Salem/ Hope Creek Environmental Audit – Post-Audit Information

Question #: LUS-1 **Category:** Land Use and Socioeconomics

Statement of Question: Please provide the following documents that were made available during the Salem and HCGS License Renewal Environmental Audit in response to Pre-Audit Question #s LUS-1 and GEN-2.

**Salem and Hope Creek Nuclear Generating Stations
PSEG
License Renewal Environmental Report
Distances to Boundary**

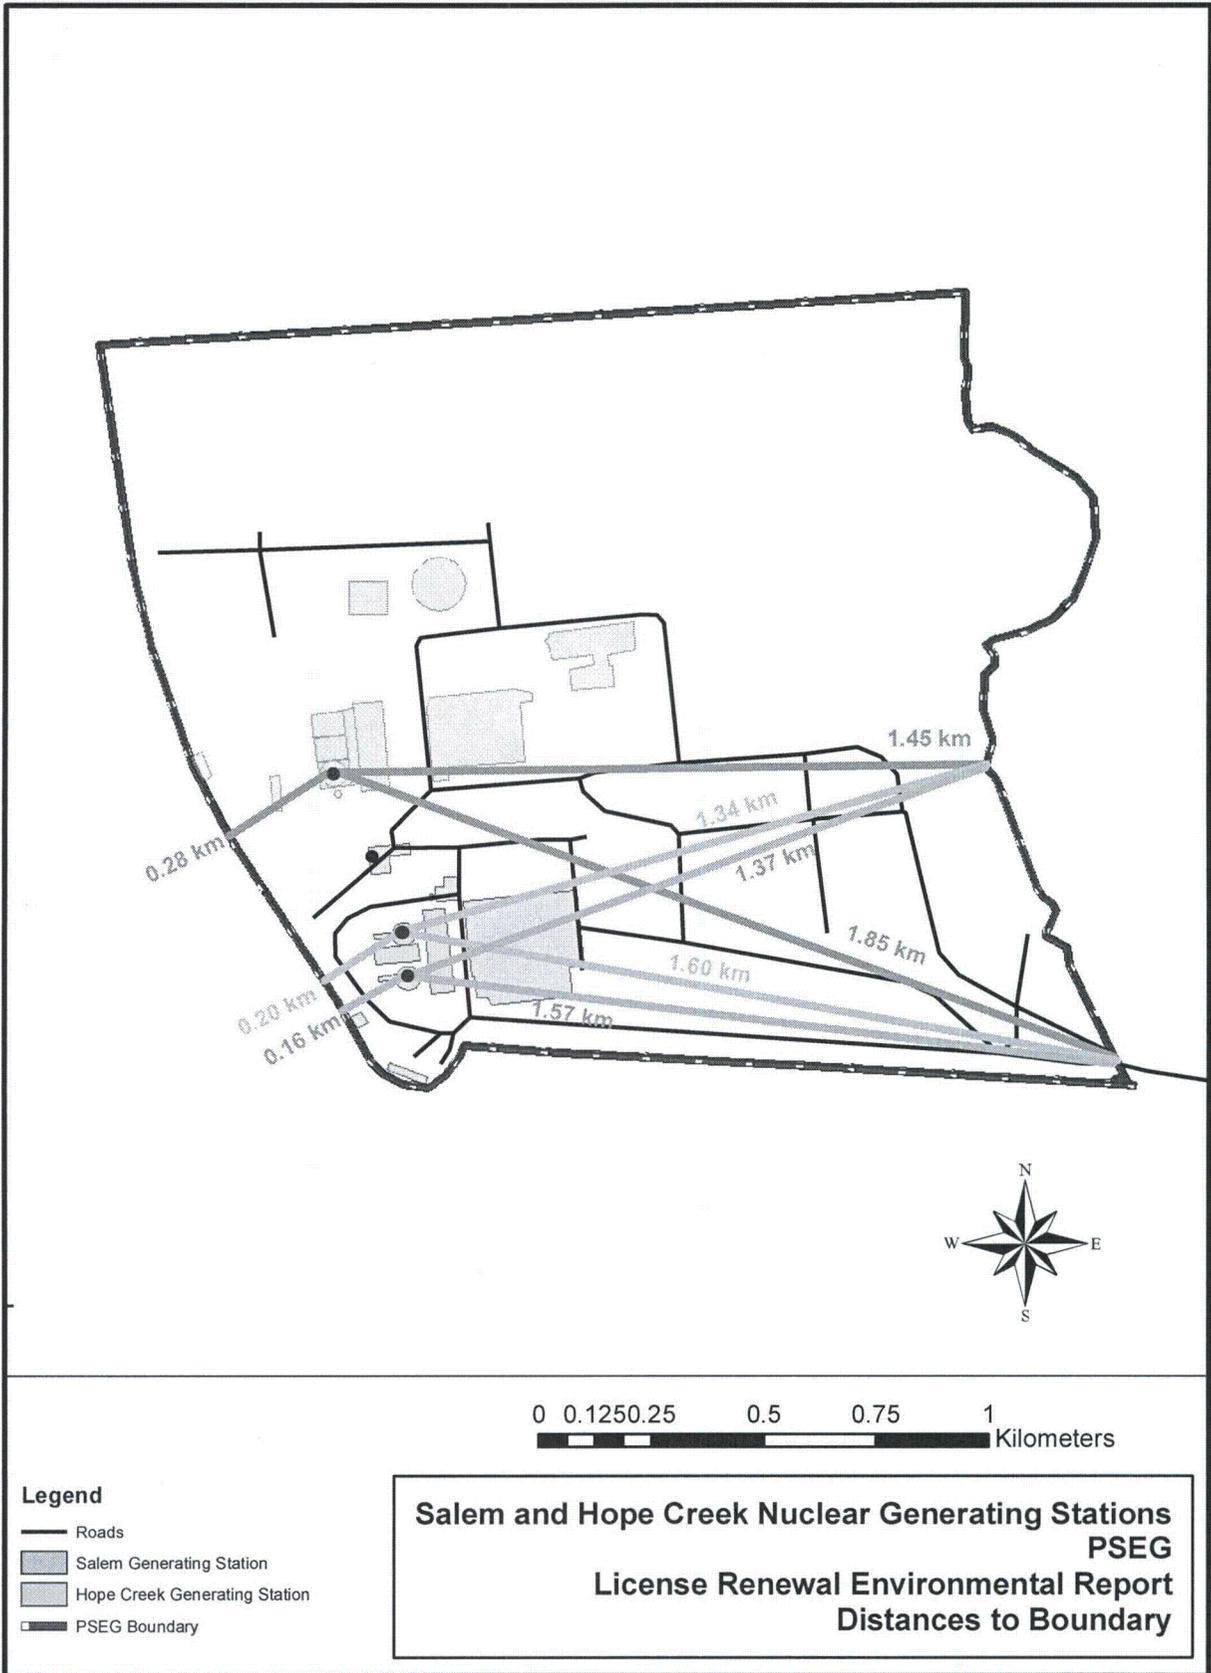
Distance from reactor buildings to site boundary, including schematic drawing.

PSEG is providing a schematic of the site, with measurements from each reactor to (1) the nearest eastern site boundary, (2) the nearest western site boundary, and (3) the point where the access road enters the property.

The distances are as follows:

From Salem Unit 1:

- To the closest point of the PSEG boundary (Delaware Estuary): 0.16 km
- To the access road at the boundary: 1.57 km
- To the closest point on inland PSEG boundary: 1.37 km

From Salem Unit 2:

- To the closest point of the PSEG boundary (Delaware Estuary): 0.20 km
- To the access road at the boundary: 1.60 km
- To the closest point on the inland PSEG boundary: 1.34 km

From Hope Creek:

- To the closest point of the PSEG boundary (Delaware Estuary): 0.28 km
- To the access road at the PSEG boundary: 1.85 km
- To the closes point on the inland PSEG boundary: 1.45 km
